MT. SAN JACINTO COMMUNITY COLLEGE DISTRICT
ADDENDUM NO. 1
BID NO. 2019-015
CONSTRUCTION OF SHADE STRUCTURES AND SITE WORK AT
MENIFEE VALLEY CAMPUS

ADDENDUM NO. 1

SHADE STRUCTURES AT MT. SAN JACINTO COLLEGE - MENIFEE VALLEY CAMPUS

DSA No. 04-1176729 File No. 33-C3 RCA Job No. 1-51-07

AS-1.4

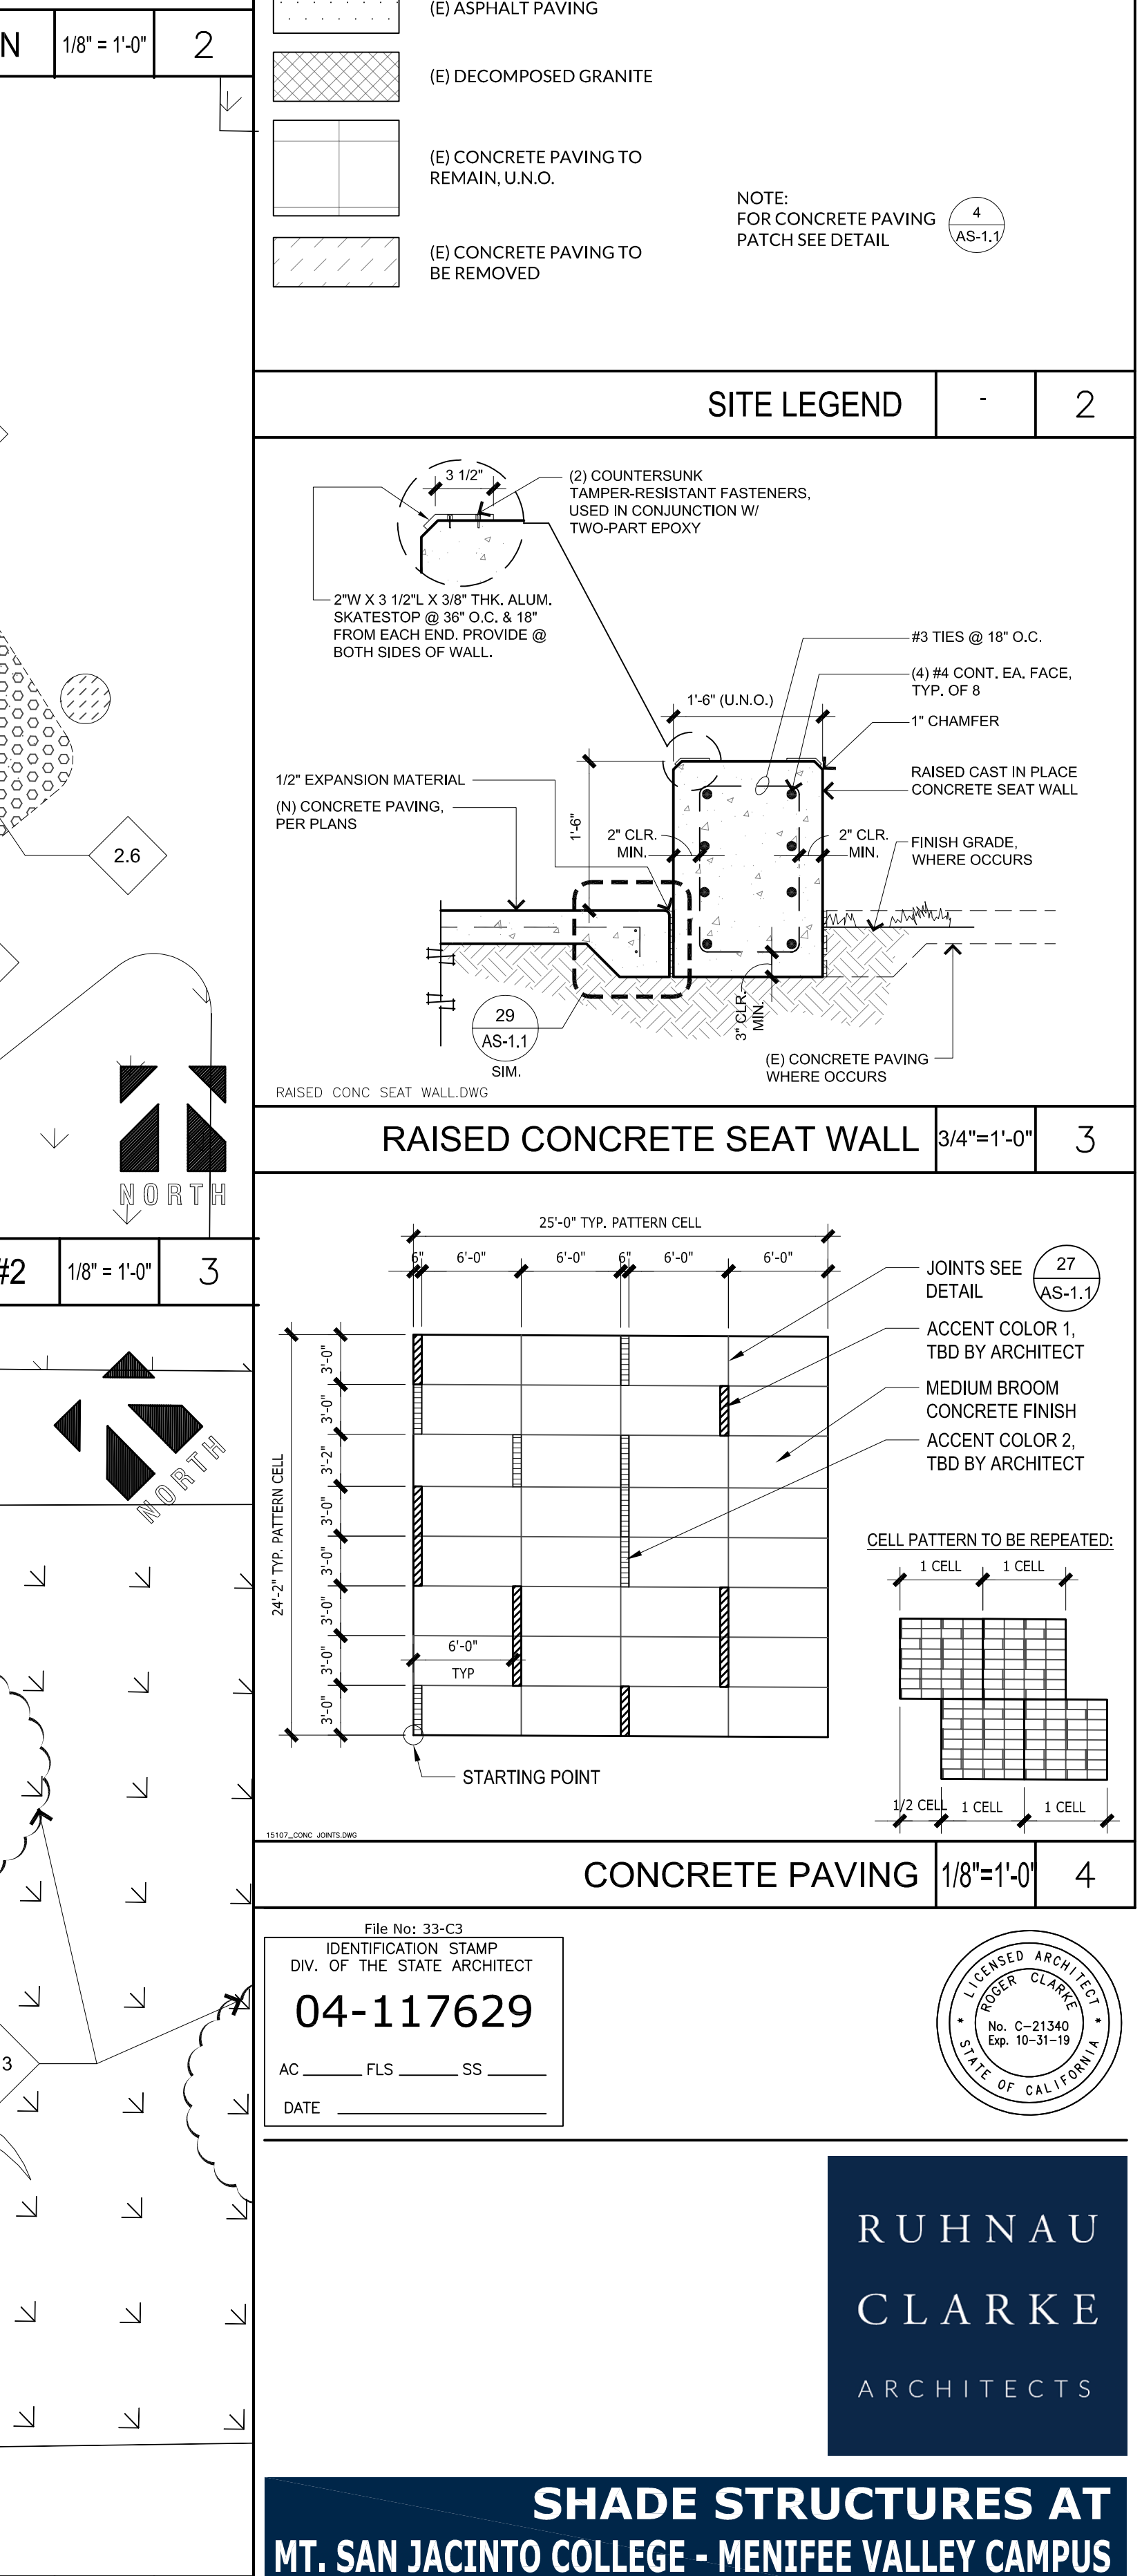
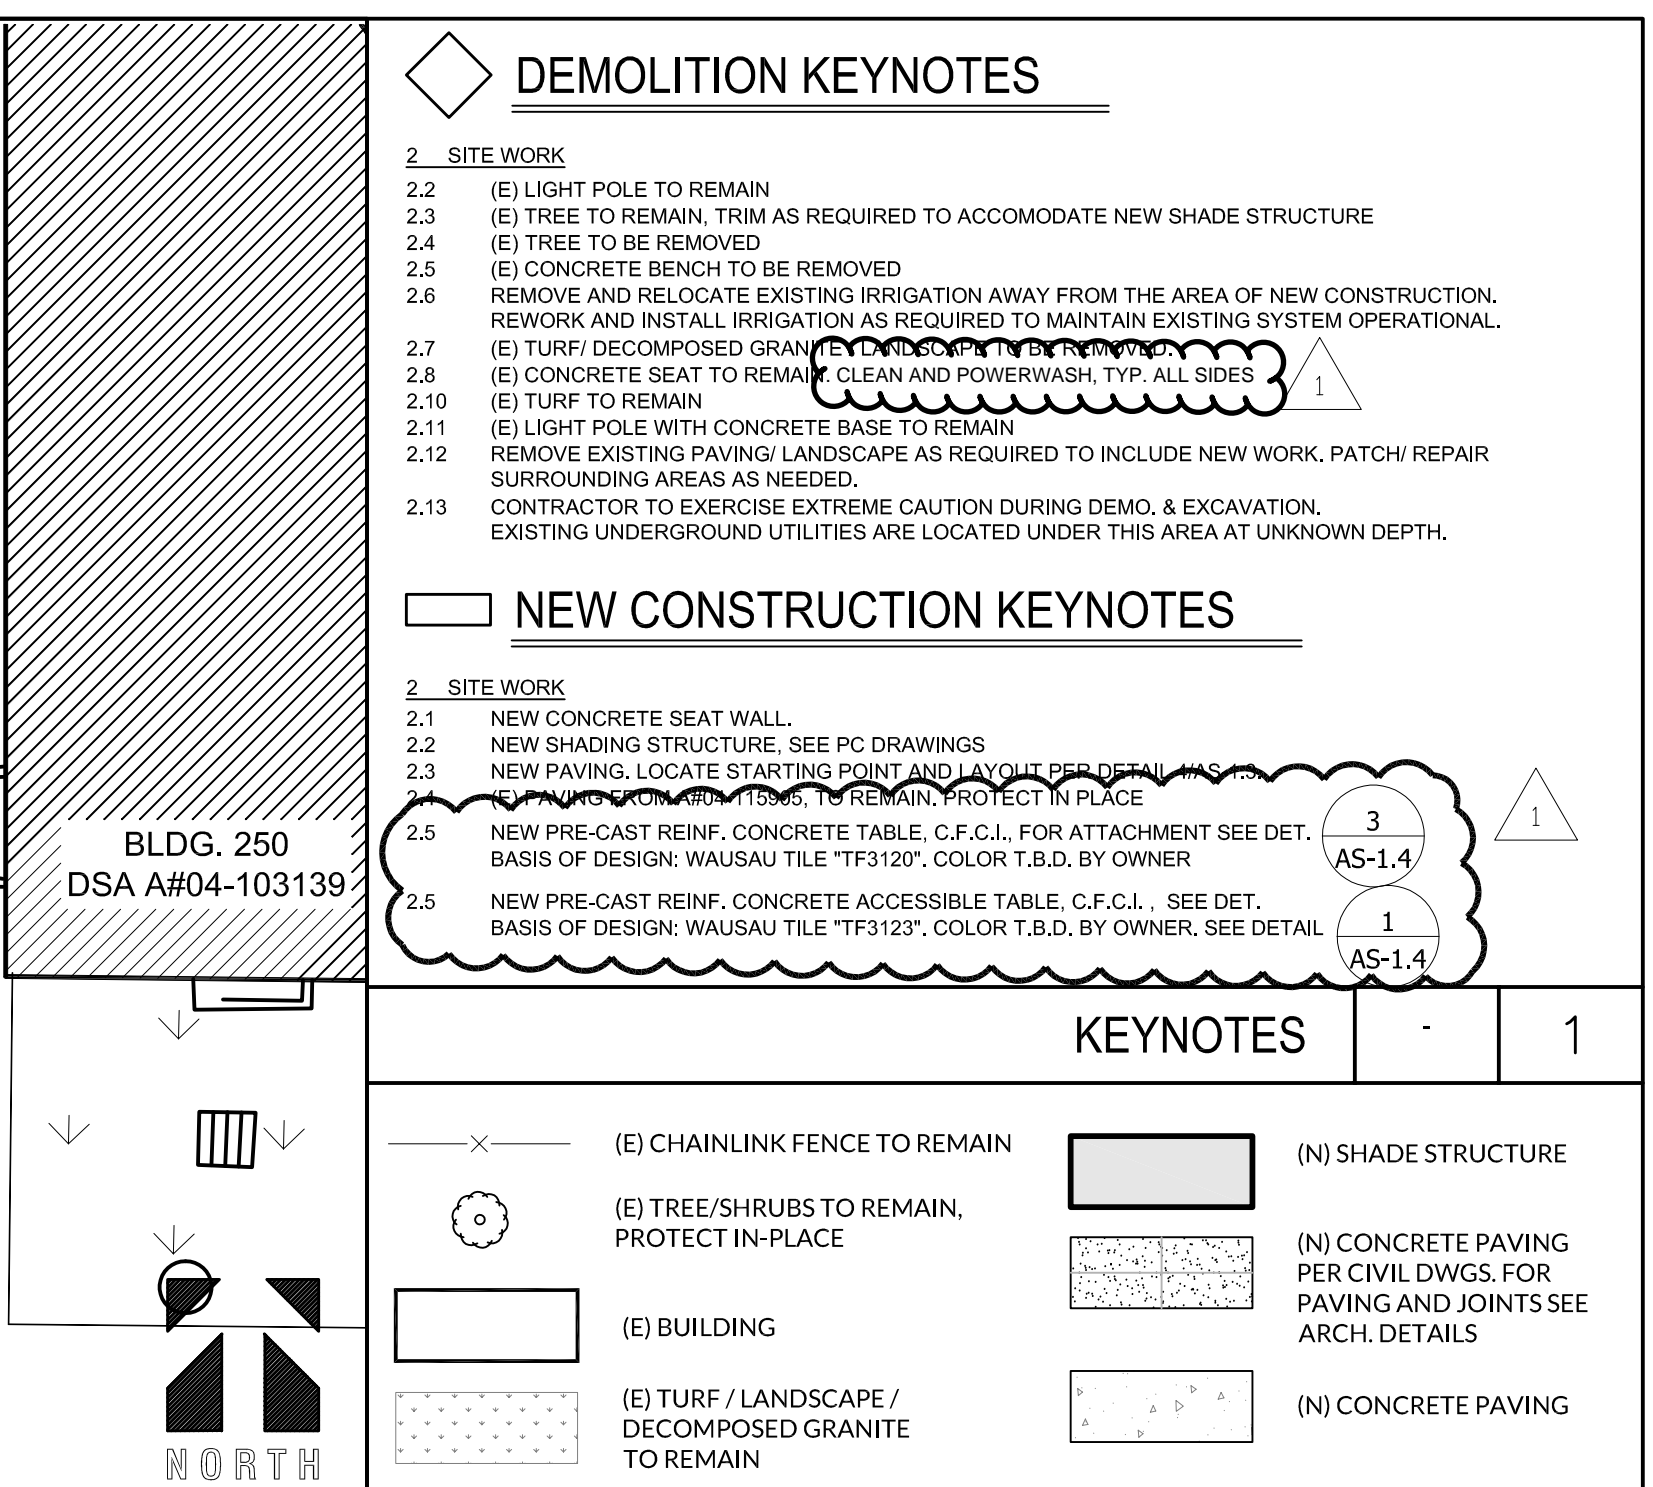
- Item No. 1.3 Reference Sheet T-1 – Title Sheet:
 - 1.3.1 Sheet Index, add new Architectural sheet AS-1.4 – Site Details
- Item No. 1.4 Reference Sheet AS-1.3 – Site Plan Enlarged:
 - 1.4.1 Revise per clouded areas of attached revised Sheet AS-1.3.
- Item No. 1.5 Reference New Sheet AS-1.4 – Site Details:
 - 1.5.1 Add attached new detail Sheet AS-1.4 in its entirety.
